Response to llion's Proposal

Commentary on Adding the Blocker to the Current Production Trigger Assembly

Sear shape

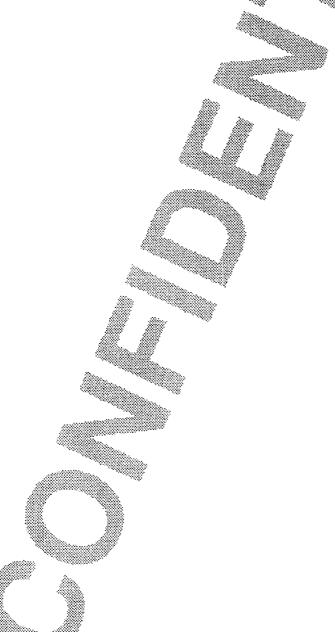
The cross-sectional shape of the SPL sear is dog-boned as a concession to the MIM manufacturing process. The dog-bone shape also has the added benefit in that it does not provide a large area to support a film of congealing lubricant between the side of the sear and the side plates of the trigger housing. In addition, the side cavities in the sear provide relief for debris that could accumulate between the sear and side plate, decreasing the possibility of the debris impeding the function of the sear.
